## **Core Bus Corridor 5: Blanchardstown**

17th April 2020

### North Circular Road Junction

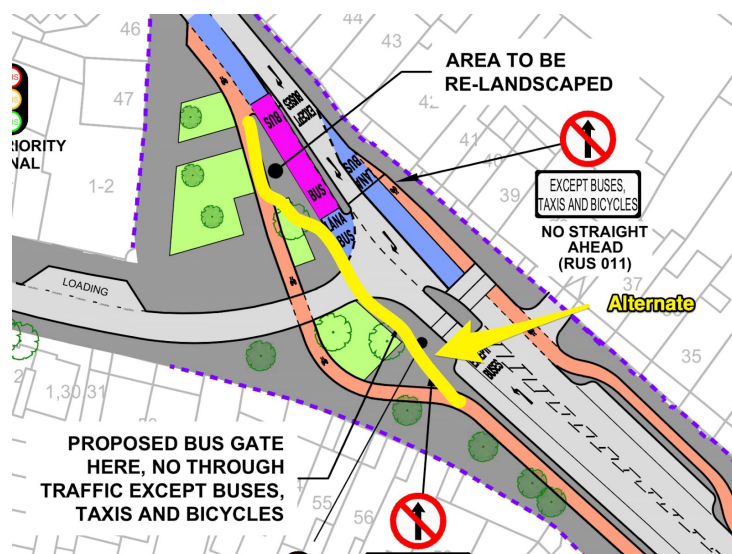
The proposed North Circular Road junction (map 30) is a minor improvement on the previous round but falls well short of the best possible design. The Griffith Avenue / Swords Road junction (CBC2, map 29) provides a great template to follow at this location. It provides a high-quality Dutch-style protected junction.
